SCITUATE PLANNING BOARD MINUTES November 16, 2023

Continued - Public Hearing – Major Site Plan Review and Stormwater Permit – Stearns Meadow – Water Treatment Plant – 453 CJC Hwy

Stearns Meadow Drinking Water Treatment Plant

Construction Phase Stormwater and Dewatering

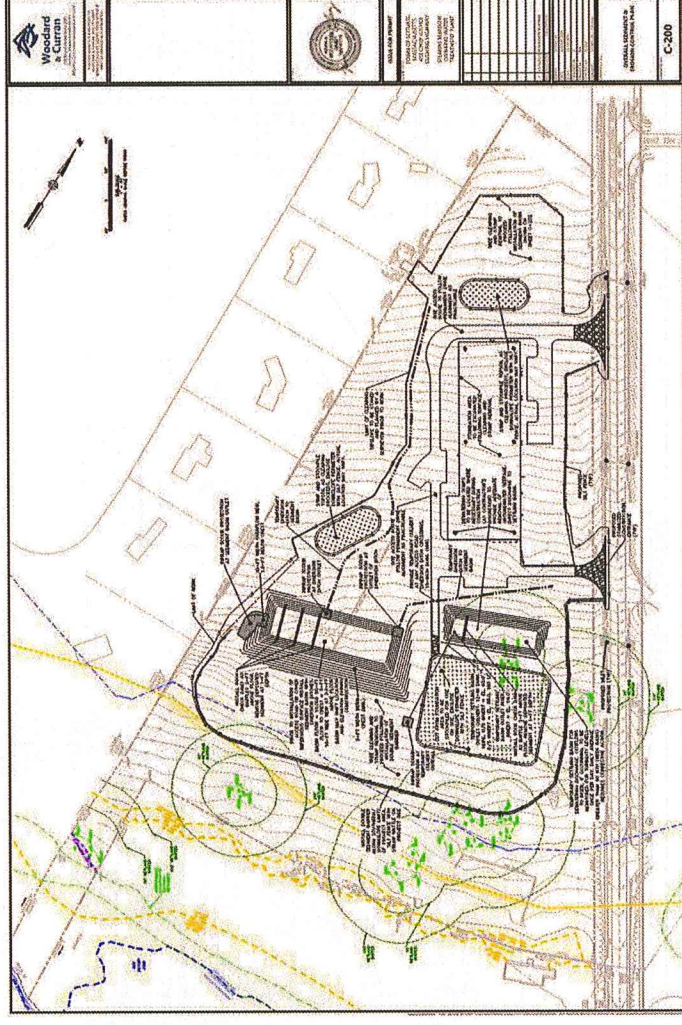
Mr. Robbins referred to the Construction Phase Stormwater and Dewatering slide of the presentation and pointed out the dewatering basin and the overflow discharge. Mr. Pritchard said it looks like a point source discharge and asked how it is spread. Mr. Robbins said there is outlet protection with the riprap and then it heads down the slope.

Mr. Pritchard said the sump appears to hold a quarter of a million gallons, so if they dewater 60,000 gallons an hour, there is probably about 4 hours before the basin is full. Mr. Robbins said they do not expect to get that much water and the dewatering is limited by the pump rate. There was continued discussion about the flow rate of ground water. Mr. Pritchard said the Board needs to look how this is managed.

Ms. Joseph agreed that more information is needed on this for the next meeting; she also said the applicant should look at adding a level spreader.

Mr. Bruce Arbonies resident at 23 Gannett Pasture Lane and Chair of the Water Resources Commission asked about the discharge from the dewatering slide and the 33,000 cubic foot basin. Mr. Robbins pointed out the temporary stormwater basin for the site and the dewatering basin; they are to be kept separate and the stormwater basin should not be used for overflow unless carefully controlled. The applicant does not expect that to ever happen.

Mr. Pritchard said there should be a condition that the stormwater basin cannot ever be used in an overflow situation.

- ▶ Temporary perimeter controls, diversion ditches, surface stabilization, and sediment storage.
- ▶ Basin sized to provide 33,000 cubic feet of storage (3,600 cubic feet per disturbed acre).
- ▶ Dewatering discharges to be directed towards settling basin.
- ▶ 2022 GP for Massachusetts requires monitoring of dewatering discharges when in proximity to high quality receiving waters.
- ▶ Daily inspection of dewatering operations and sampling of discharges for turbidity measurement.
- ▶ Weekly average above 50 NTU requires corrective action.
